# VOLVO PENTA

## Service Bulletin

### New Carburetors

3.0GLP-J, 4.3GL-J, 4.3GL-JF, 5.0GL-J, 5.0GL-JF

3.0L

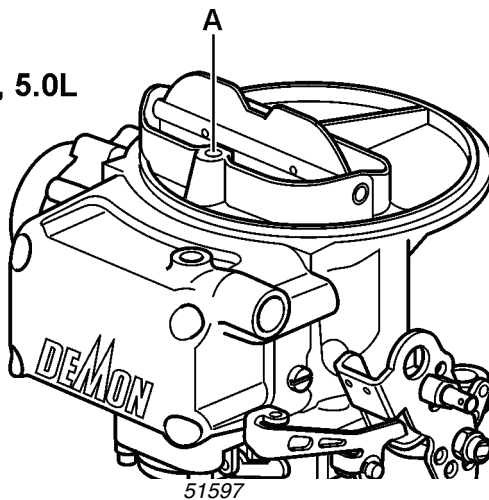
A new carburetor was recently introduced in production on 3.0L, 4.3L, and 5.0L engines. The new carburetor can be identified by the name Demon™ on the front of the float bowl.

**NOTICE!** Demon carburetors **do not** have J-tubes **A**. Earlier marine carburetors (Holley) had J-tubes to control venting of the fuel bowls. This venting function has been designed into the carburetor housing on the Demon carburetors.

4.3L, 5.0L

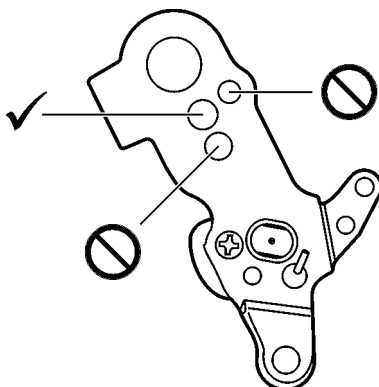
Throttle cable connection **B** to the Demon carburetor engines is the same as the Holley carburetor engines. Note correct pin location (middle hole) as depicted by the check-mark.

51598

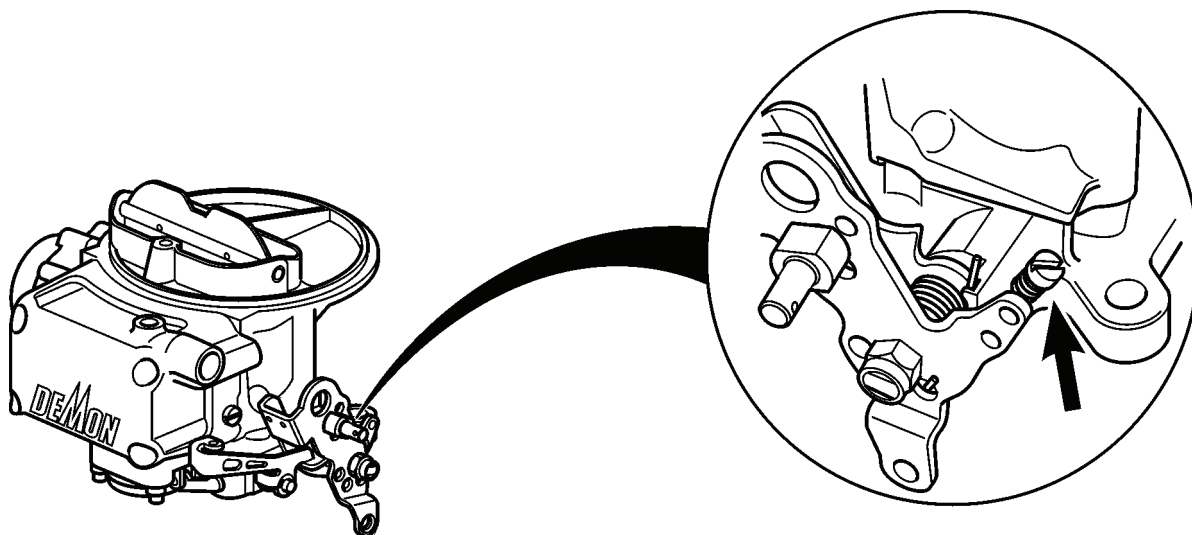
Idle speed and choke adjustments to the Demon carburetors are very similar to the Holly carburetors. The arrow in the illustration below depicts the idle speed setting screw.
